OSR SUBDIVISION

APPLICATION	NUMBER H	oldover	DATE _	May 1, 2003
APPLICANT _	OSR Subdivision			
TPRIIOR (REDII	Subdivision

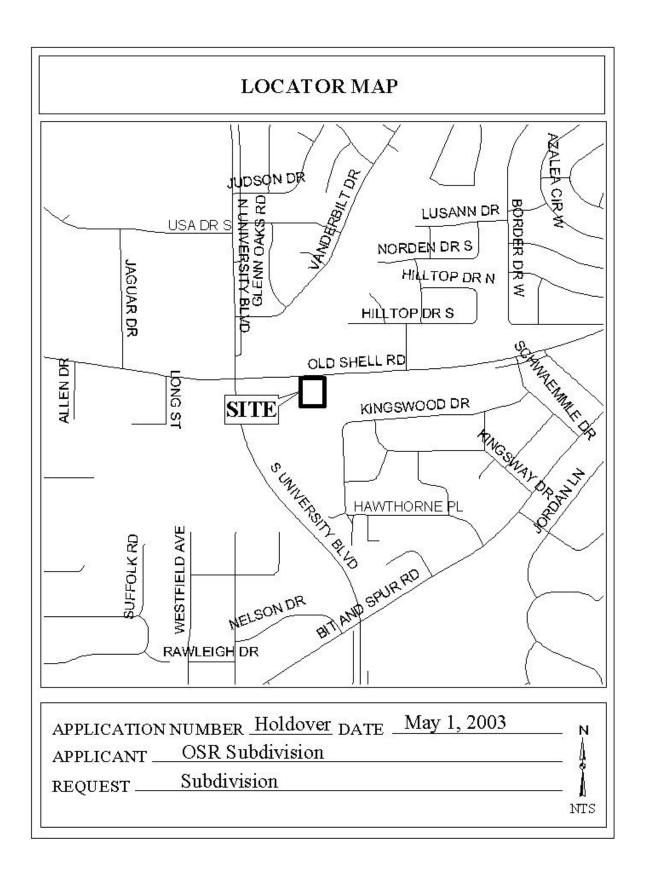
<u>Engineering Comments</u>: Must comply with all stormwater and flood control ordinances. Any work performed in the right of way will require a right of way permit.

<u>Traffic Engineering Comments</u>: Driveway number, sizes, location and design to be approved by Traffic Engineering and conform to AASHTO standards.

The site fronts Old Shell Road, a planned major street and as such a 100-foot right-of-way is required. The existing right-of-way is variable; however, the dedication of the necessary right-of-way to provide 50-feet from the centerline of Old Shell Road should be required. Lot 1 is developed and no additional curb cuts should be allowed. As a method of access management, Lots 2 and 3 should be limited to one curb cut each, with the location and design to be approved by Traffic Engineering.

With modifications, the plat will meet the minimum requirements of the Subdivision Regulations and is recommended for Tentative Approval subject to the following conditions: 1) the dedication of the necessary right-of-way to provide 50-feet from the centerline of Old Shell Road; and 2) placement of a note on the final plat stating that Lot 1 is limited to the existing curb cuts, and Lots 2 and 3 are limited to one curb cut each, with the location and design to be approved by Traffic Engineering.
